INFORMATION REQUEST

APPLICATION NO: MCUI/3/2018

PROPERTY ADDRESS: 17-25 PARK RIDGE ROAD, PARK RIDGE QLD 4125

- **MATERIAL CHANGE OF USE - SERVICE STATION, FOOD AND DRINK OUTLET AND CHILD CARE CENTRE**
-

Figure 3.2: Safe intersection sight distance (SISD)

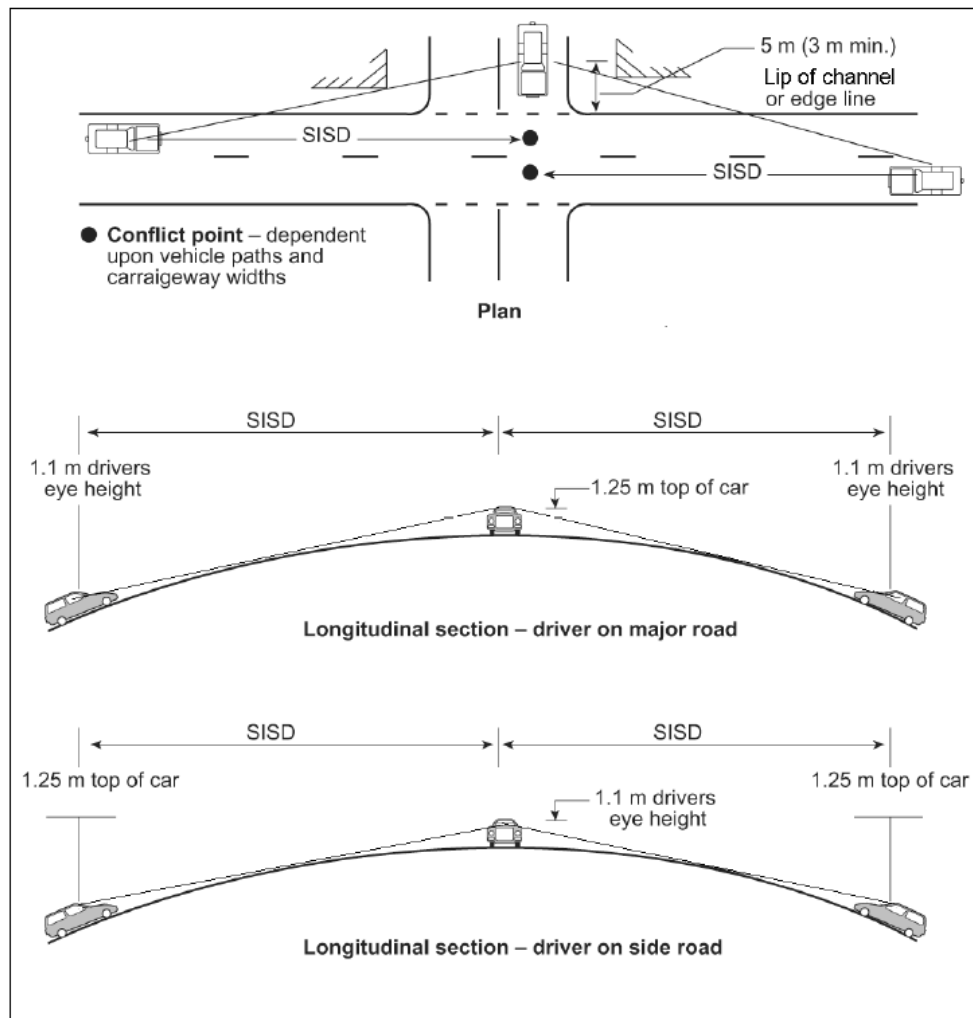
- 5.1. Amend the Traffic Impact Assessment report and demonstrate that a Safe Intersection Sight Distance (SISD) can be achieved for all vehicles interacting with the site (including trucks on the approach) due to the crest of the road and to use an operating speed based on the 85th percentile (km/h) of Park Ridge Road for the northern access of the site by providing a longitudinal section as per image below. An SISD will need to be demonstrated to Council that it can be achieved for the northern access for the interim and the ultimate design of Park Ridge Road.
